ADDRESS: 2036 DELANCEY PL

Proposal: Construct addition Review Requested: Final review

STAFF RECOMMENDATION: The staff recommends approval, pursuant to Standards 9 and 10.

THE MINUTES OF THE 701ST STATED MEETING OF THE PHILADELPHIA HISTORICAL COMMISSION

ELEVATION, STREET **VIEWS & PHOTOS**

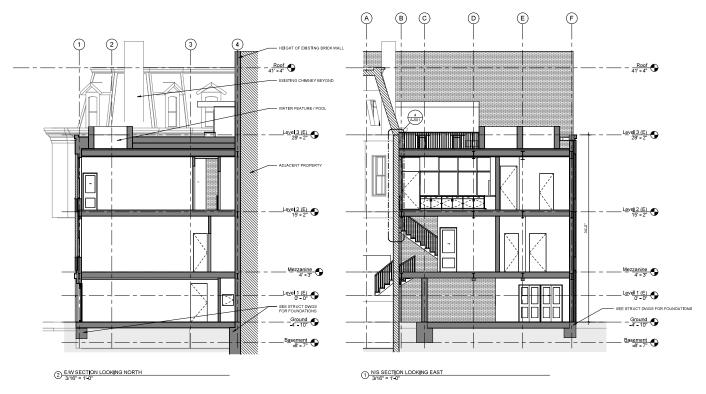
- The proposed construction removes a non-historic element of the property. The new work is differentiated from the old and is generally compatible in massing, scale, and materials to the historic building. The application complies with Standard 9. The applicant should include historic gate in final plans as requested by Historical Commission. The applicant should confirm whether additional railings will be required by the building code around pool areas on the roof. If they are required, these railings should be incorporated into the design for the final review by the Historical Commission.

2036 Delancey Place Plans & Axonometric View

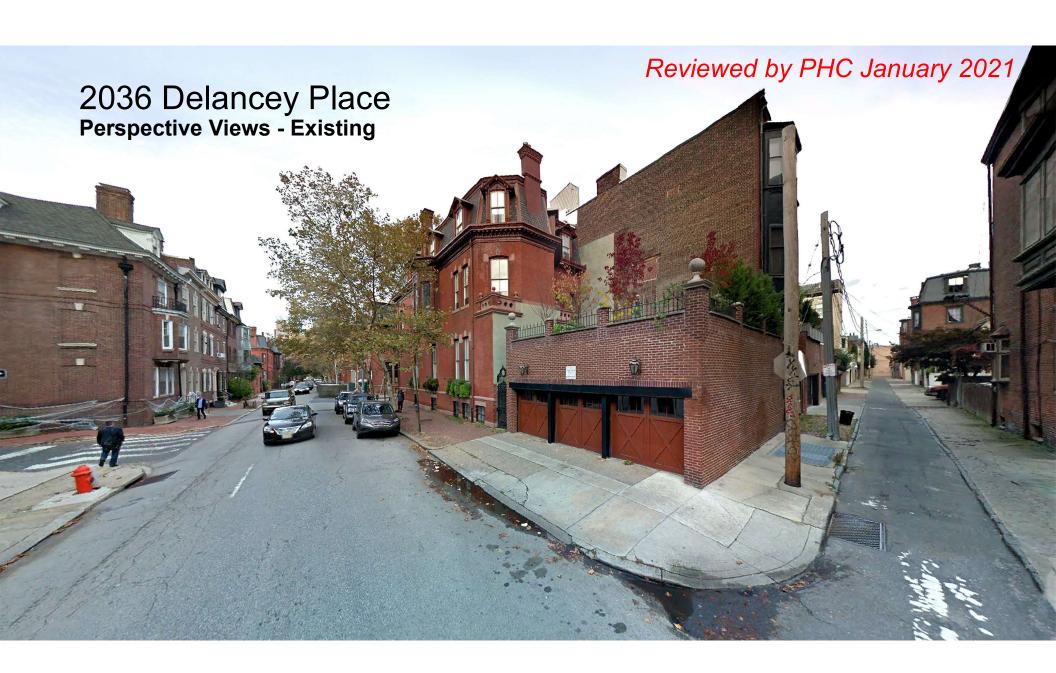
The Architectural Committee voted to recommend denial in-concept, pursuant to Standard 9. They objected to the height of the addition, which extended above the cornice line of the existing house, the use of solid railings and parapet walls, the size and scale of the masonry openings on the proposed addition, the use of a lighter material at the full first floor, and the connection between the historic building and existing building.

Following the Architectural Committee, the applicant revised the application to respond to the Committee's recommendation by reducing the height, number of windows, replacing the dark panel area with a change in brick coursing, revising the glass connection to the existing house to step back through all levels, and changing the material of the base of the building.

- The revisions made between the original application and the Historical Commission submission respond to the Architectural Committee's comments.
- The nature of the connection, the materials, and elevation have improved between the Architectural Committee submission and the Historical Commission submission.
- The existing iron gate that is shown in plans but not in the rendering should be retained.
- Details such as the articulation of the garage doors can be worked out in the final review stage.

2036 Delancey Place West Elevation & South Elevation

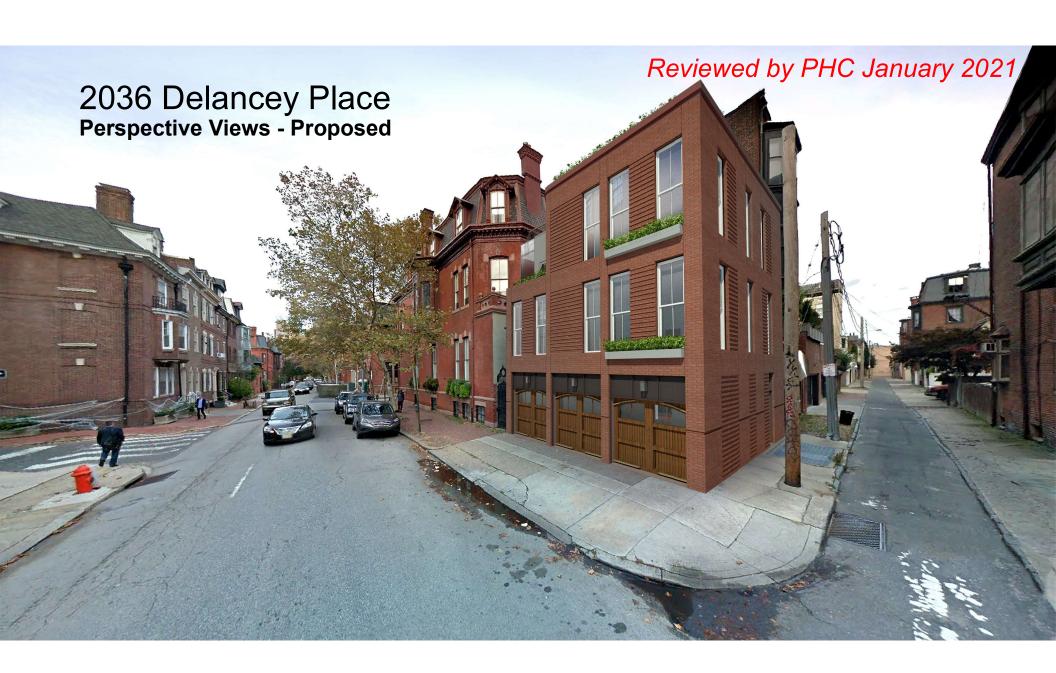
- Ms. Gutterman expressed concern over the massing and use of dark, solid wood elements that make the building appear taller and less respectful of the historic house.

- Ms. Stein expressed concern with the size and scale of the masonry openings along the side elevation, noting that they seem out of scale with the neighborhood and opining that they had a warehouse as opposed to a residential aesthetic. She opined that the limestone base is awkward, noting that many of the buildings in the area have lower watertables, and that the limestone base puts emphasis on its material in a way that feels out of scale with the character of the neighborhood. She opined that the design of the addition should relate more to the historic building.

- Mr. Jung responded that they could revise the first-floor cladding to show more brick
- Mr. McCoubrey questioned the elevated portion of the building shown in dark wood.

- Mr. Jung responded that the area clad in dark wood is set back approximately five feet, eight inches from the street edge and is a parapet. He noted that they could lower it and asked whether a different or more muted material would be appropriate.

- Mr. McCoubrey suggested lowering the height of all elements of the proposed addition to keep it below the major cornice line at the base of the mansard.

Mr. Cluver suggested carrying the recess of the entrance vestibule the full height of the addition to maintain a separation at all levels of the addition and provide a cleaner transition between the existing building and addition.
